Florida Department of Transportation Interchange Access Request Methodology Letter of Understanding (MLOU) Amendment #2

**SUBJECT: Interstate 95 and SW 10th Street (S.R. 869) Interchange Modification Report
Amendment 2 to the Methodology Letter of Understanding (MLOU)**

**METHODOLOGY LETTER OF UNDERSTANDING - ADMINISTRATIVE AMENDMENT
#2**

Interstate 95 and SW 10th Street (S.R. 869)
Interchange Modification Report

Exhibit 1 - I-95 Historical AADT Volumes

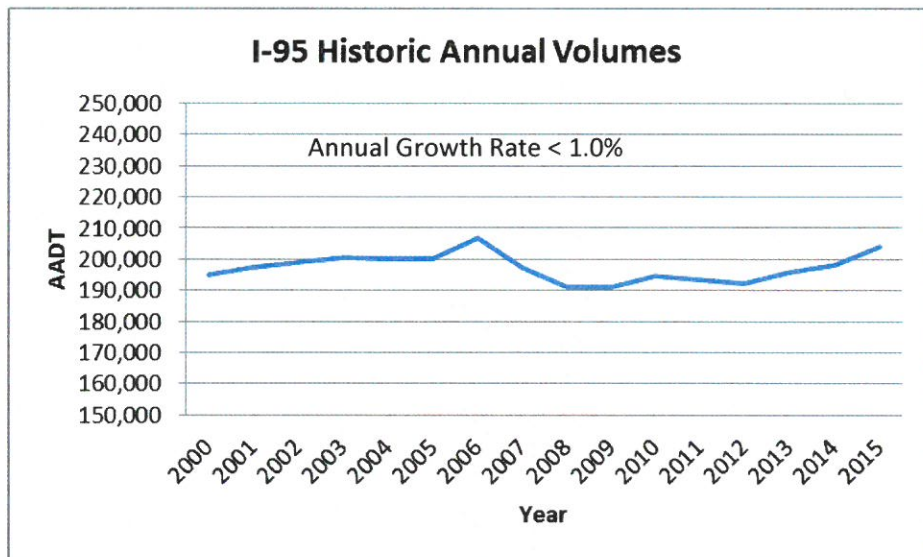
The current identified value for Standard K on I-95 mainline is 8%, however recently collected traffic data within the project area has demonstrated a lower value is appropriate. Applying a Standard K factor of 8% produces a design hour trend or DDHVs which significantly exceed historical growth trends.

Exhibit 1 shows that the historical AADT growth is <1%. Traffic volumes from the telemetered traffic monitoring site (TTMS) #0163 on I-95 just north of 48th Street in Pompano Beach (just south of SW 10th Street) were used to calculate the growth rate. The volumes show a flat growth rate over the last 15 years. The chart below shows the historical AADT volumes for I-95, with a 2015 AADT of 204,200.

The proposed revision to the traffic factors for the project are outlined below:

Roadway	K	D	24T	DHT_f	PHF
I-95 Mainline	7.0	50.5 to 56.7	4.0 to 6.0	2.0 to 3.0	0.85 to 0.99
I-95 Ramps	8.0	100	4.0 to 6.0	2.0 to 3.0	0.85 to 0.99
SW 10 th Street	5.7 to 12.8	50.0 to 83.4	3.0 to 8.0	2.0 to 3.0	0.93 to 0.97
Hillsboro Boulevard	6.3 to 9.0	50.0 to 93.3	3.0 to 9.0	2.0	0.94 to 0.96
Sample Road	3.9 to 9.5	50.7 to 71.2	3.0 to 7.0	2.0 to 3.0	0.92 to 0.96
